UNITED STATES PATENT AND TRADEMARK OFFICE

APPLICATION NO.	FILING DATE	FIRST NAMED INVENTOR	ATTORNEY DOCKET NO.	CONFIRMATION NO.
09/933,169	08/21/2001	Larry A. Druga	114302.1721	6443
30734	7590	10/01/2003		
BAKER + HOSTETLER LLP WASHINGTON SQUARE, SUITE 1100 1050 CONNECTICUT AVE. N.W. WASHINGTON, DC 20036-5304			EXAMINER CECIL, TERRY K	
			ART UNIT	PAPER NUMBER
			1723

Office Action Summary

DETAILED ACTION

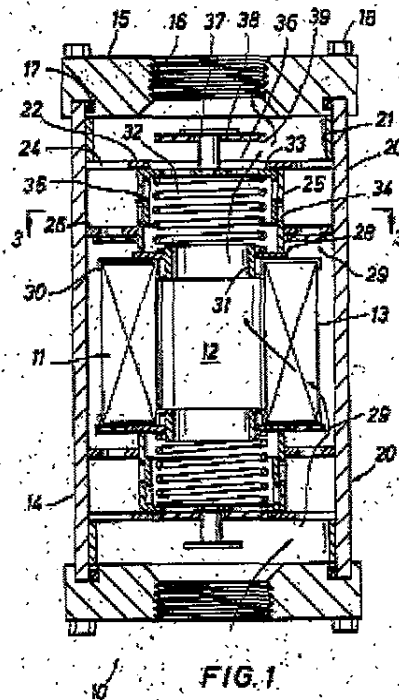
3. Claims 3 and 4 are rejected under 35 U.S.C. 103(a) as being unpatentable over Cooper (U.S. 3,996,137), in view of McDuffie (U.S. 3,799,347). Cooper discloses a fluid filter that teaches the valve configuration of claims 3 and 4. The bottom of figure 2 thereof is reproduced on the next page.

The first, second, third fluid flows and the arrows thereof are shown above as the forward flow, relief flow, and reverse flow, respectively [as in claim 3], wherein the first flow path includes the inlet 2, the space between the filter element 27 and the housing 6, the filter element, a central passage 35, and the outlet 3 [as in claim 4]. Cooper does not teach the inlet, outlet, and filter to be in a coaxial arrangement. However, such is shown in the art of McDuffie (see figure 1) [as in claim 3]. It is considered that it would have been obvious to one ordinarily skilled in the art at the time of the invention to have the inlet and outlet (2,3) of Cooper to be in the coaxial arrangement of McDuffie, since McDuffie also teaches a filter/valve configuration wherein the inlet and outlet can be reversed. The modification would allow the invention of Cooper to be used in hydraulic systems where a symmetric configuration is required (e.g. systems disclosed in

4. Claims 2-9, 11-12 and 16-21 are rejected under 35 U.S.C. 103(a) as being unpatentable over Humbert (U.S. 3,456,800) in view of McDuffie. Figure 4 of Humbert has been reproduced below.

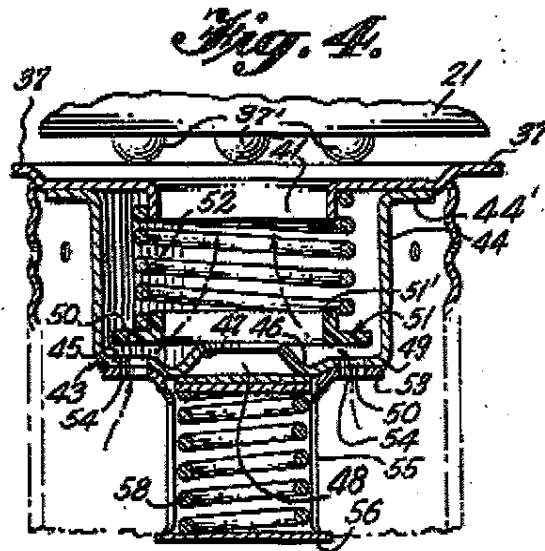
As shown above, Humbert discloses a first retainer 44 (or alternately 37 and attached wall 34), a first spring, a first disk 51, a second retainer 55, a second spring, and a second disk 57 (see figure 2), wherein the disks are operative to compress in opposite directions toward their respective retainers. In addition, as shown in figure 1, Humbert teaches the aforementioned dual direction bypass valve in combination with a filter 33 having an inlet and an outlet (12 or 13) and an end cap separating the first and second disks (bottom portion 45 can be viewed an end cap [as in claim 21] between disks 51 and 57 and the retainer—37 and attached wall 34) [as in claim 2].

As shown in figure 4, Humbert also discloses the reverse flow bypass means to include a first disk 51 against a plurality of peripheral holes 50 in the end cap 45 operable to open toward the first retainer means (37) for fluid to bypass the media [as in claim 6].

As shown in figure 2, Humbert also discloses the forward bypass means to include a second disk 57 against a central opening 48 in the end cap 45 operable to open toward the second retainer means 55 to bypass the filter media [as in claim 7], wherein the forward flow bypass means (the second fluid flow path) leads through the front valve body (that includes 44) and through the rear valve body (that includes 55) to the outlet 13 [as in claim 8] and the reverse bypass means (third flow path) leads from outlet 13 through the central passage, front valve body (via holes 50) to bypass the rear valve body (including 55) and the media [as in claim 9].
